# North-South Cycle Superhighway (CS6) Stonecutter Street to King's Cross

Response to issues raised  
September 2016

# Executive Summary

*Angled kerbs at edge of stepped track with gentle gradient*

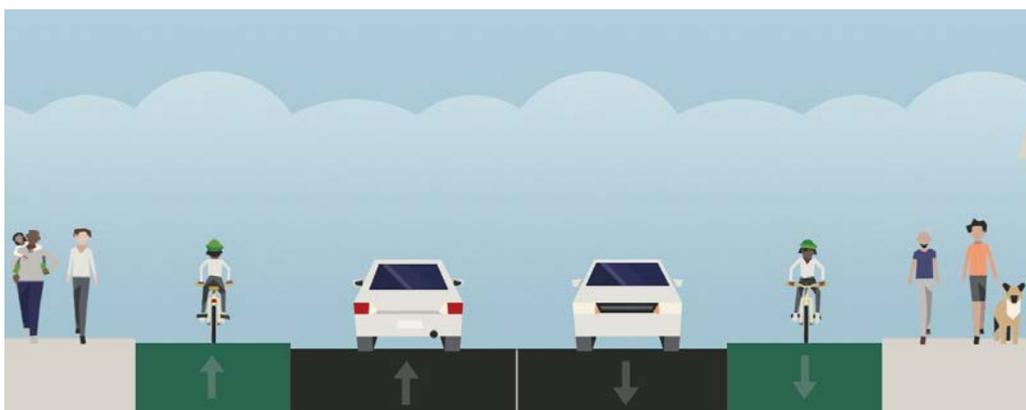
If the cycle track was on the inside of the bays, cyclists would be obscured from the visibility of drivers turning into the side roads. These side roads are cul-de-sacs so

drivers turning in from Farringdon Street will already be aware of the cycle track when they turn out.

The kerbs at the parking bays will be low. This means that the gradient of the angled kerb would be gentle to allow drivers to transition from the carriageway to the bays. See below.
